APPLICATION NO.	FILING DATE	FIRST NAMED INVENTOR	ATTORNEY DOCKET NO.	CONFIRMATION NO.
10/500,505	06/29/2004	Nicasius G.T. Van Gennip	De 020005	4394

Office Action Summary

DETAILED ACTION

FIG. 1

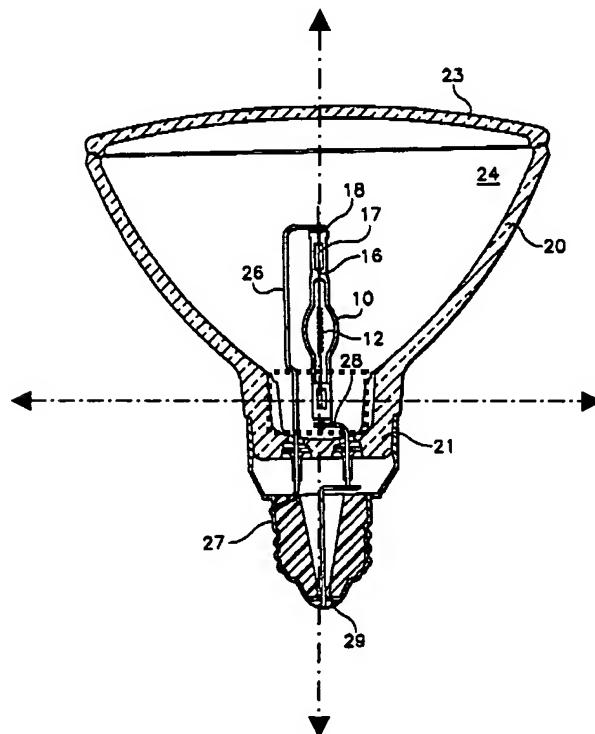
8. Claims 1-6 are rejected under 35 U.S.C. 102(b) as being anticipated by GIBSON ET AL. (US 6,049,169), which discloses:

- A discharge lamp for a motor vehicle (10);
- A return pole (26);
- A reflector and reflective surface (inner portion of 20 that guides/directs waves of light);
- A hollow reflector neck (lower portion of 20);
- An inner contour of reflecting surface having a rectangular shape with rounded corners and is x-axis asymmetrical and y-axis symmetrical (Fig. 1 below); and
- An asymmetrical burner centered in the reflector (10).
